FILE NUMBER: Z0124-0342
REQUEST FOR: Rezoning – Planned Development Multifamily
CASE MANAGER: John Cervantes, Planner

Applicant: Marc Tolson of Arrive Architecture, LLC., on behalf of Rodeo Center Development, Ltd.
Requested Action: Zoning Change to Planned Development – Multifamily would allow 135 build-to-rent patio homes and 142 build-to-rent townhomes with modifications to the development standards and a comprehensive plan amendment to change the future land use designation from Commercial to Medium Density Residential.
Location: 21701 IH 635

ATTACHMENT 10 – CONCEPT PLAN (EXHIBIT C)

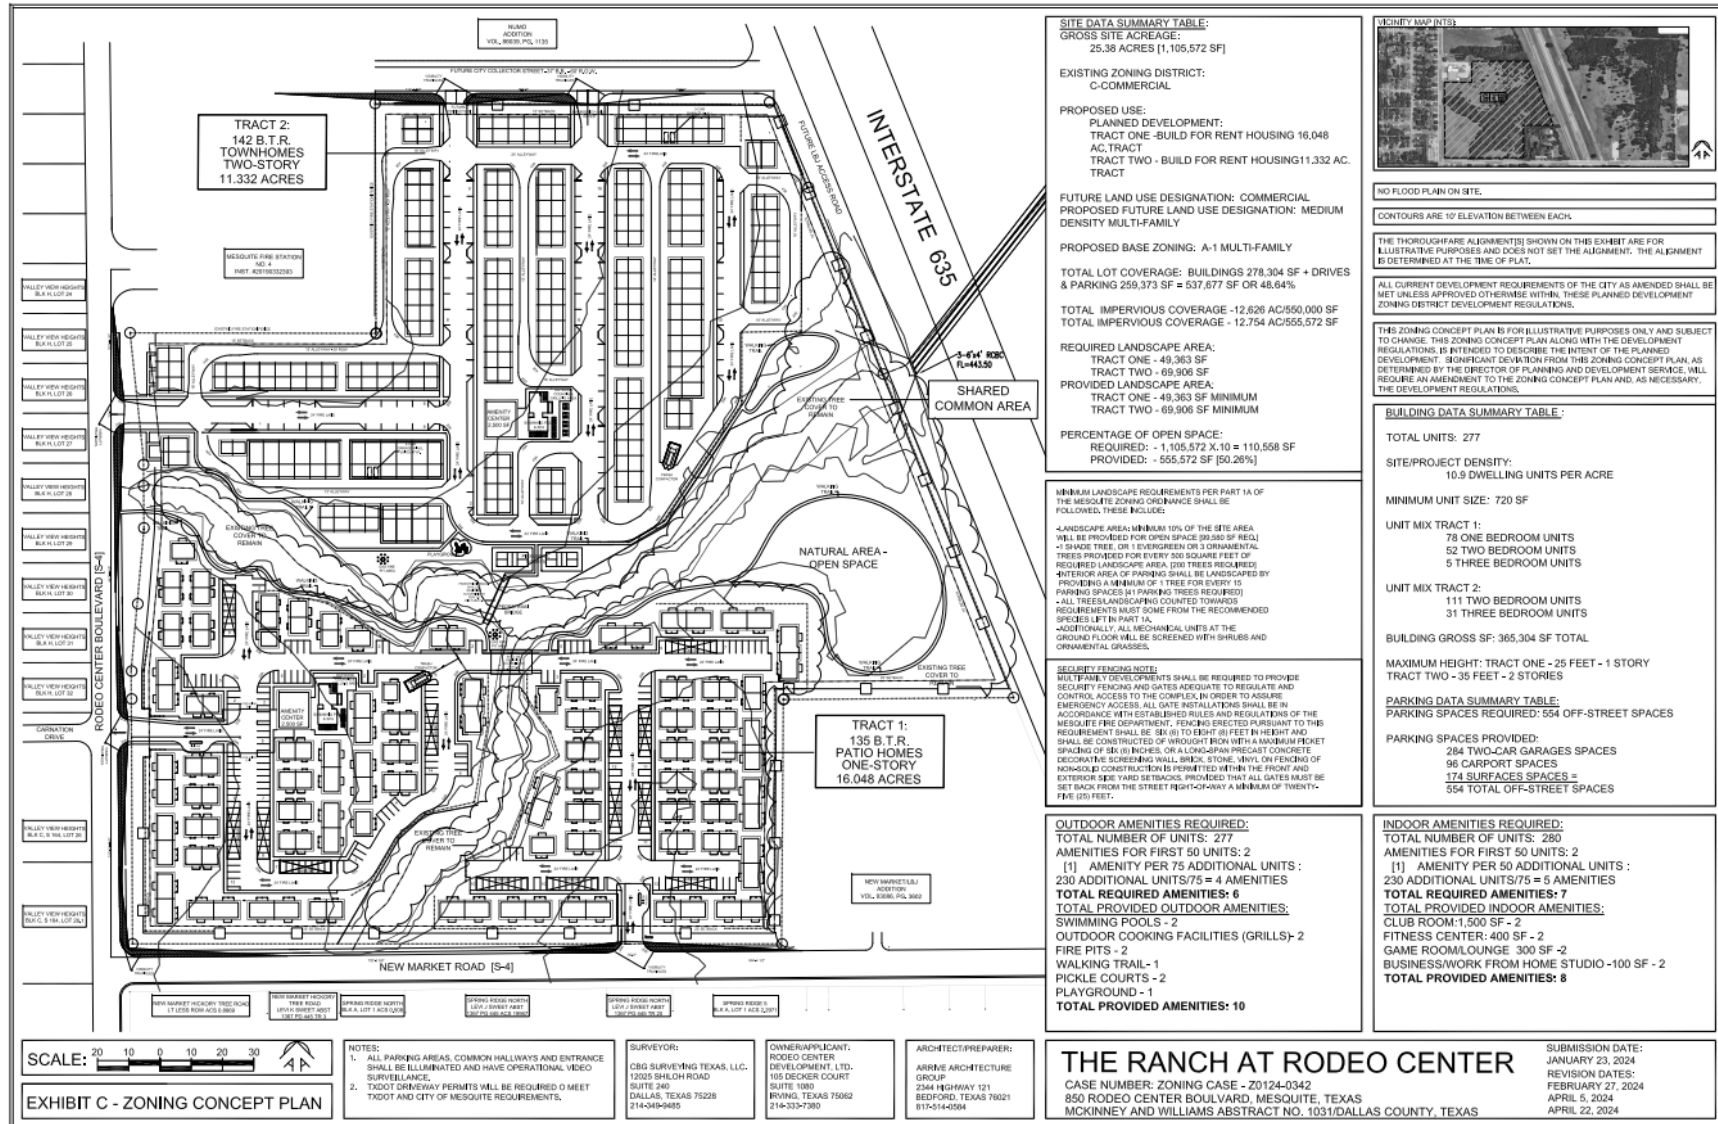
Attachment 10 (Exhibit C) includes the concept plan. Staff has reviewed the concept plan based upon the supplementary development standards for multifamily in Section 2-501 of the Mesquite Zoning Ordinance and the proposed PD development standards. Staff finds that all requirements are being met except those identified in the following section.

Staff Comment: Per Sec. 2-501.K.1., 567 parking spaces are required for a parking ratio of 2.04 parking spaces per unit. The applicant does not meet the City's parking requirements by providing 554 parking spaces at an overall ratio of 2.00 parking spaces per unit. The applicant proposes reducing the requirement to increase the parking by 10% to 8%. In addition, a total of 380 parking spaces are covered or roughly 69% of the total parking spaces.
